BMW 3 Series (E 36) All models with 4-cylinder petrol engine

Noises from the area of the air conditioning compressor.

Bulletin

Tensioner pulley

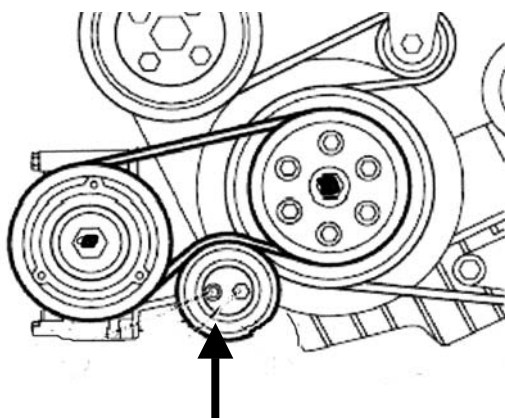
If there are complaints with these vehicles in relation to the noises from the area of the air conditioning system compressor, one possible cause is the tensioner pulley for the drive belt. The ingress of dirt into the tensioner pulley leads to a noise from the area of the compressor developing in certain speed ranges. In the event of hasty diagnosis, these noises may lead to compressor damage being suspected. In order to avoid incorrect diagnoses it is essential that, with the drive belt removed, the tensioner pulley is checked for noises.

During series production, the tensioner pulley was replaced by a modified version (with rear protective cover). If the tensioner pulley is replaced, it should be ensured that the new version is used.
